City of Mississauga Department Comments

Date Finalized: 2023-04-12 File(s): A74.23

The applicant requests the Committee to approve a minor variance to allow the construction of an addition proposing a lot coverage of 46.2% of the lot area whereas By-law 0225-2007, as amended, permits a lot coverage of 40% of the lot area in this instance.

Property Address: 4619 Jethro Court

Appendix 1 – Transportation and Works Comments

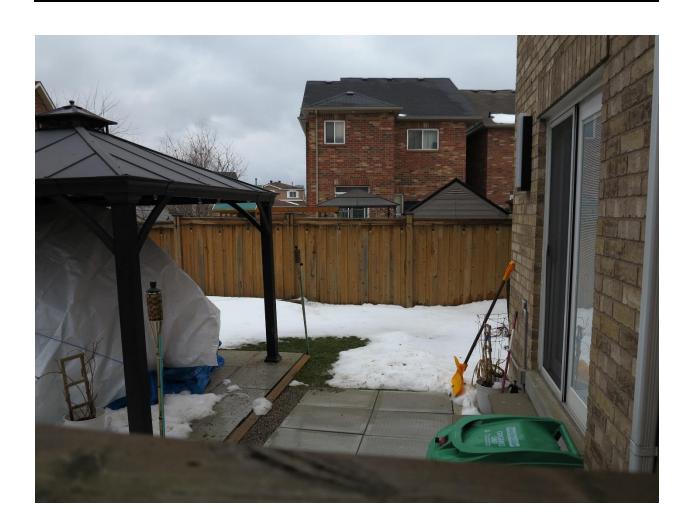
We are noting for Committee's information that any Transportation and Works Department concerns/requirements for the proposed addition will be addressed through the Building Permit process. We note that the existing drainage pattern for this property is such that any drainage from the rear yard is directed to the rear lot catch basin on the abutting property to the northeast.
